FOREST GROVE PLANNING COMMISSION MEETING
COMMUNITY AUDITORIUM, 1915 MAIN STREET
MONDAY, JUNE 17, 2013 -- 7:00 P.M.

Planned Residential Development Staff Report and Recommendation

LAND USE REQUEST: Modification of the Casey Meadows Planned Residential Development. The modifications include eliminating several tracts and enlarging the adjacent lots; allowing zero-lot-line homes; reducing side yard setbacks from 4 feet to 3 feet; potentially reducing the number of lots from 101 to 99; and allowing a different housing type.

FILE NUMBERS: PRD-13-00371 and PRD-06-02

SHEET
 3 OF 3

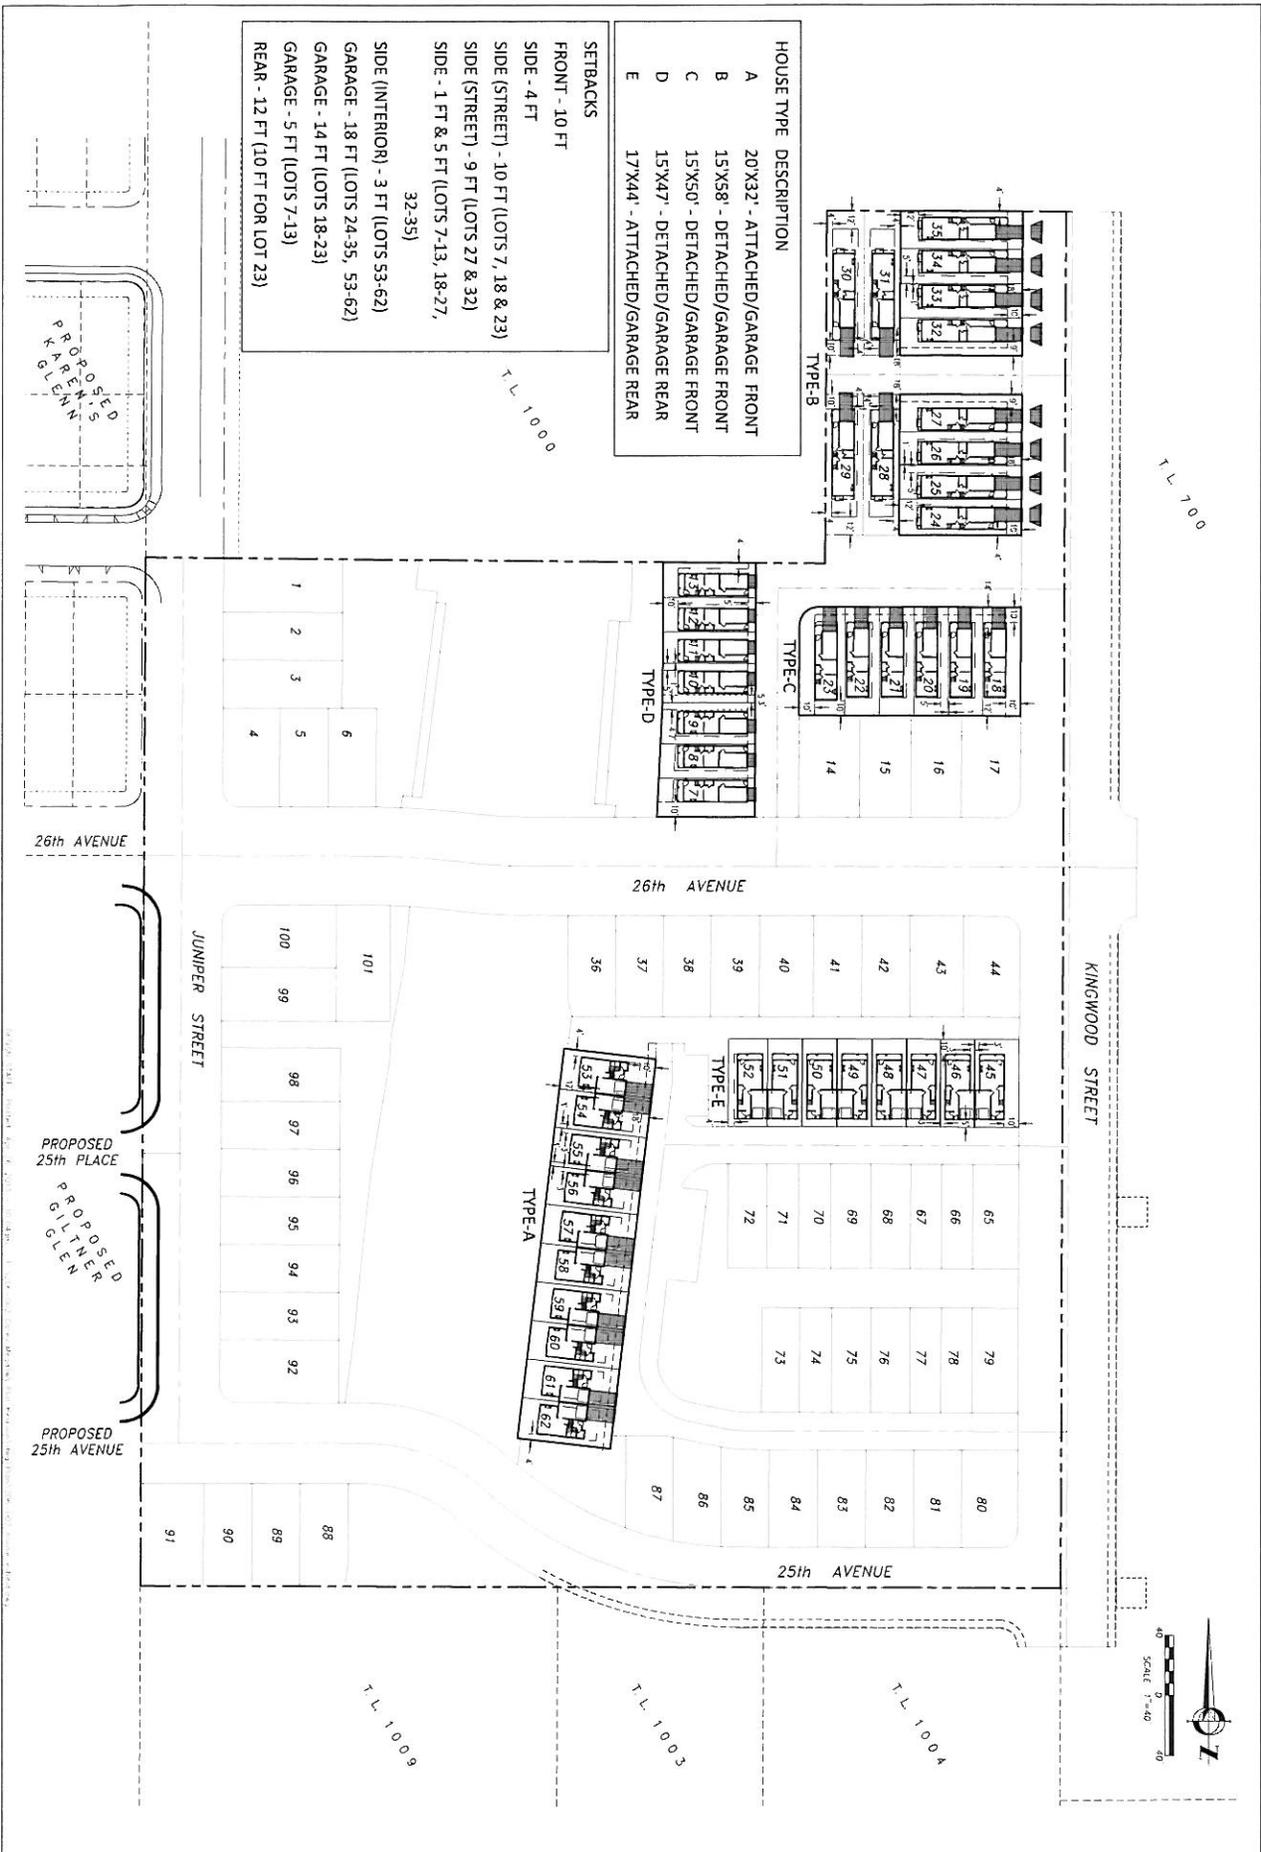
- Removal of tracts N, P and Q, all located in the northeast quadrant of the project. These tracts were platted to provide pedestrian access to the adjoining lots. The area within the tracts would attach to the rear yards of the adjacent lots (18-23, 24-27, and 32-35). The homes abutting the tracts would remain front-loaded (i.e., their garages and front doors would be on the same elevation as originally approved).

The block with lots 14-18 is 148 feet long east-to-west and 140 feet long north-to-south. The blocks with lots 24-29 and 30-35 are 131 feet long east-to-west and 94 feet long north-to-south. The Development Code (Section 10.8.905(D)) requires mid-block pedestrian ways only if a block exceeds 500 feet in length. Staff concludes that these mid-block pedestrian ways could be eliminated if alternative pedestrian access to the public street was provided to the affected lots. To provide that access, staff is recommending a **condition** to require construction of a pedestrian path on one side of Princeton Place and one side of Adeline Court to provide connections to Kingwood Street.

- Zero-lot-line (ZLL) construction on 16 lots (7, 8, 11-13, 18-22, 25-27, and 32-34). On the ZLL side yard, the edge of the footing would be located at the property line, while the wall would be set back approximately one foot. On the non-ZLL side, the setback would be five feet. The total distance between units (wall-to-wall) would be six feet.

The ordinance to establish the Casey Meadows PRD requires a minimum four-foot-wide side yard setback for detached single-family homes. Staff supports the intended purpose of the zero-lot-line approach: provision of more useable outdoor space between units. As side yards between units are often delineated with a fence, there remains only a narrow strip between the foundation and the fence which offers limited utility to the residents. ZLL construction would offer a greater opportunity for the residents to use their side yards for something more than access or waste container storage. However, all of the homes proposed for ZLL

construction would have an east-west orientation, leaving the yards shaded much of the year, which would discourage using the yard for outdoor recreation or gardening. Furthermore, none of the proposed house plans (Types B, C and D) would have ground floor doors or windows facing the side yards, which would create an additional disincentive for active use of the yards. Staff concludes that, while ZLL construction can offer an additional amenity to the residents, in this proposal it would appear to offer only a larger area for outdoor storage and "passive" landscaping.

As problematic is the proposal to reduce the side yard setback from four feet to three feet. Combining the reduced setback with ZLL construction would allow for a 6-foot-wide yard but it would also have the effect of crowding the homes closer together, resulting in a further decrease in light and air between units and making the yards even less attractive for residents' use.

- Various revisions to the front and rear setbacks. The applicant has proposed unique setbacks for various lots: a 9-foot private street side yard setback on lots 27 and 32; and a 10-foot rear yard on lot 23.

Staff has no objection to the 9-foot-wide side yard setback proposed for lots 27 and 32, as these yards abut a private street and would not conflict with the existing 5-foot-wide public utility easement. Because this yard does not front a public street, staff would consider this to be a standard side yard with a minimum 5-foot-wide requirement.

The purpose of the proposed 10-foot-wide rear yard setback on lot 23 is not clear, as the lot shares the same dimensions as its neighbors and the floor plan proposed for lots 18-23 appears identical, and all of those other homes would have a 12-foot-wide setback.

1. Front yard and corner side yard setbacks shall be a minimum of ten feet except where there is a transformer. At these locations the setback shall be twelve feet (this is the current requirement).

2. Garages for front-loaded homes shall be setback a minimum of 18 feet. The applicant has proposed a 14-foot garage setback for lots 18-23. That would provide insufficient depth to park in front of the garages without the vehicles protruding over the Princeton Place walkway recommended above. A different house plan will be necessary in order to provide a parking pad forward of the garage. Further discussion follows in the *Off-Street Parking* section below.

3. Garages for rear-loaded homes shall be setback a minimum of 5 feet. This is consistent with the current code requirement.
4. Rear yards shall be a minimum of 12 feet except that lots 53-64 shall have a minimum 10-foot rear yard setback (the current requirement).

CASEY MEADOWS 15' X 58' FRONT LOAD DETACHED - TYPE B

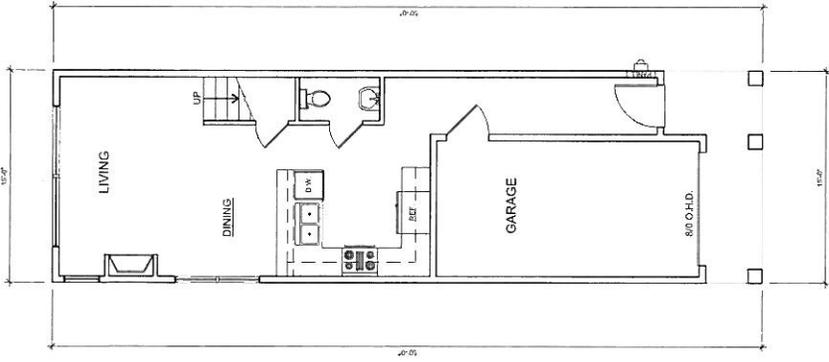
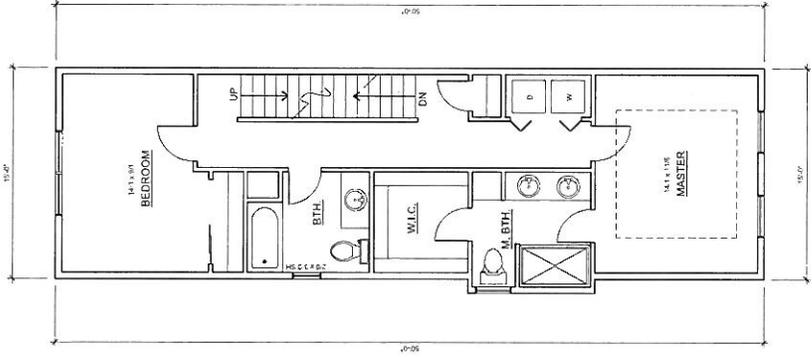
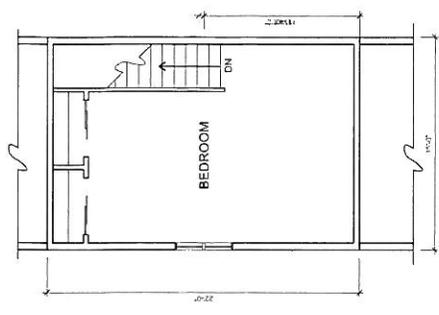
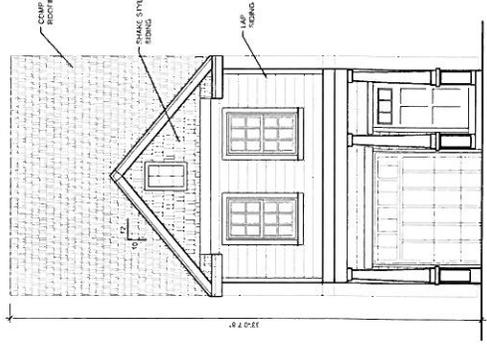
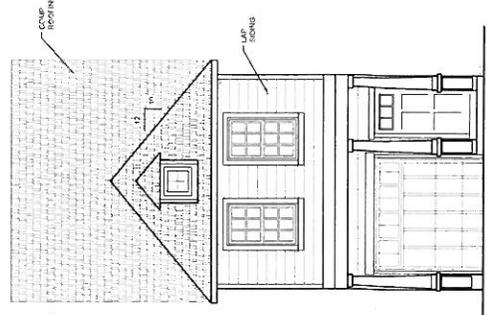
Type B: Detached, 15 by 58 feet, front loaded garage, 2 stories, to be located on lots 24-35. The homes on lots 24-35 (fronting Kingwood Street) would be zero lot line.

CASEY MEADOWS 15' X 50' FRONT LOAD DETACHED - TYPE C

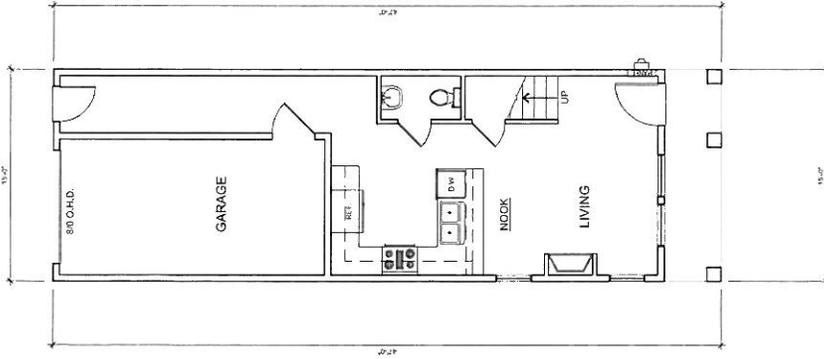
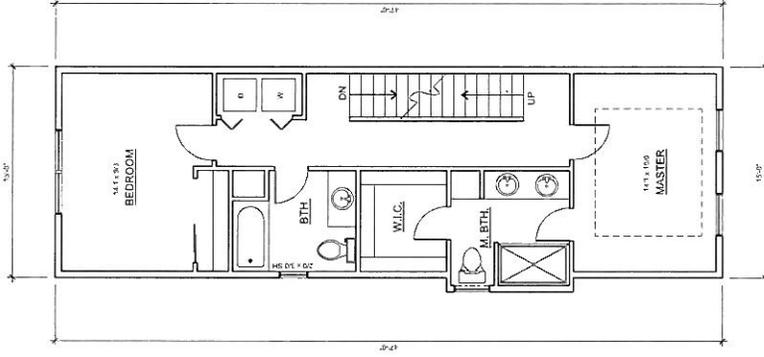
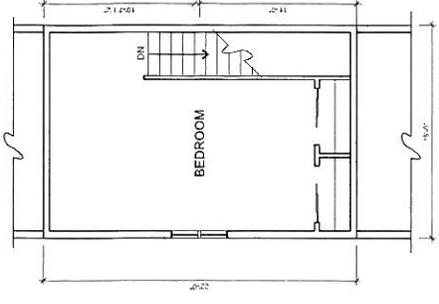
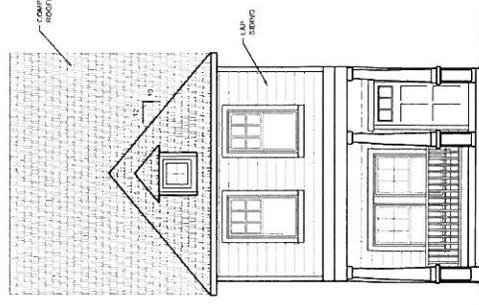
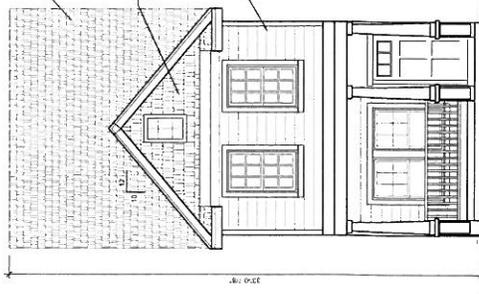
Type C: Detached, 15 by 50 feet, front loaded garage, 2 ½ stories, to be located on lots 18-23. All would be ZLL except for lot 23.

CASEY MEADOWS 15' X 47' REAR LOAD DETACHED - TYPE D

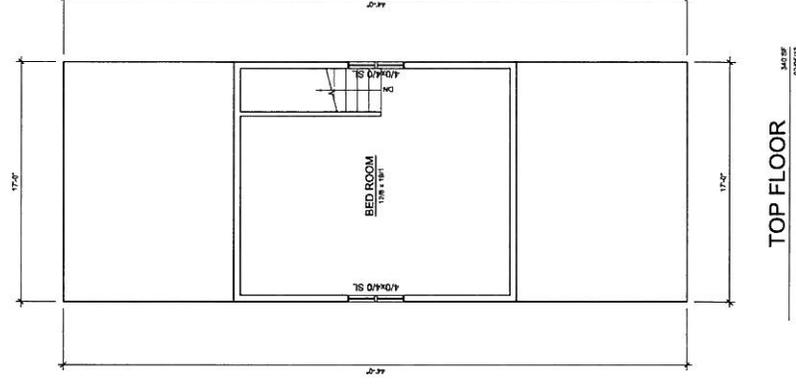
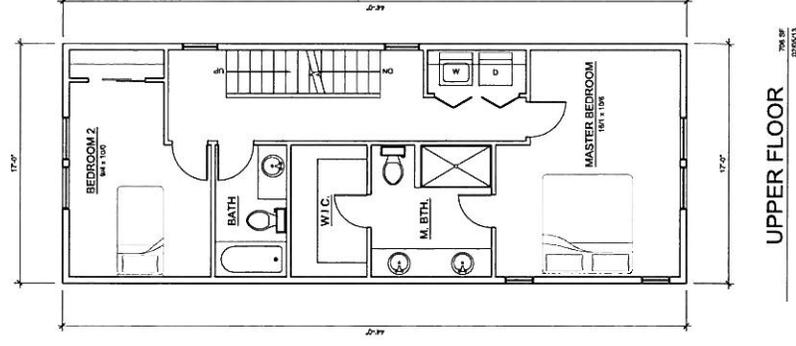
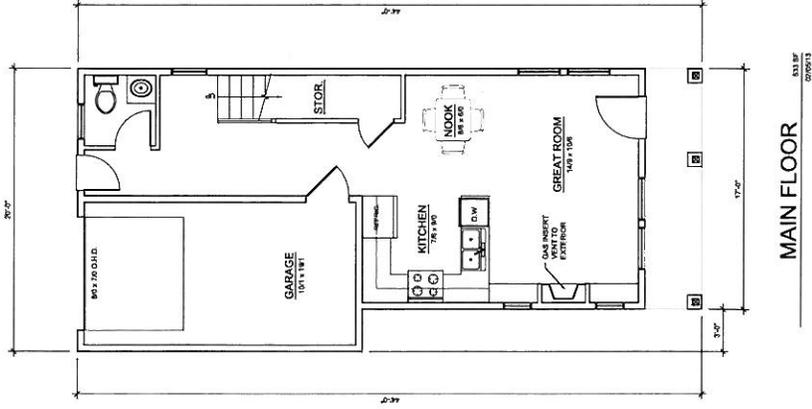
Type D: Detached, 15 by 47 feet, rear loaded garage, 2 ½ stories, to be located on lots 7-13. All would be ZLL except for lot 9.
